To: T10 Technical Committee  
 From: Rob Elliott, HP (elliott@hp.com)  
 Date: 14 December 2003  
 Subject: 03-354r1 SPC-3 Specify initiator ports in EXTENDED COPY target descriptors

**Figure 1 — Example of a complex copy manager environment**

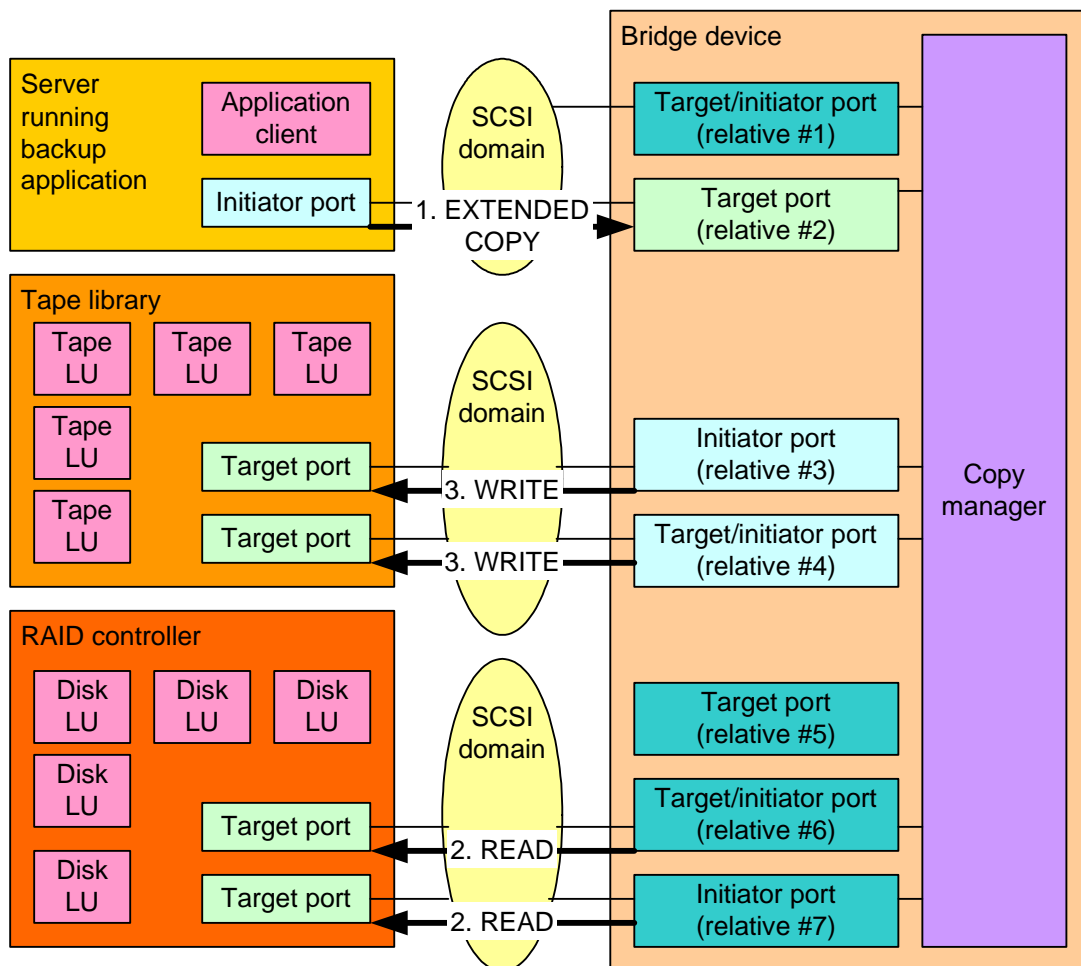
A copy manager can be in a SCSI device with multiple initiator ports, each potentially in different SCSI domains (thus with access to a different set of target ports).

1. Send EXTENDED COPY to copy manager through target port #1 (or #2)
2. Copy manager reads from disks using initiator ports #6 and/or #7
3. Copy manager writes to tapes using initiator ports #3 and/or #4
4. EXTENDED COPY completes through target port #1 (or #2)

EXTENDED COPY is silent today on which initiator port to use. This proposal adds a relative initiator port field to the EXTENDED COPY target descriptor so an initiator port to use can be specified. The default value of zero means the choice is vendor-specific (the copy manager can use any initiator port it wants), which is compatible with current implementations.
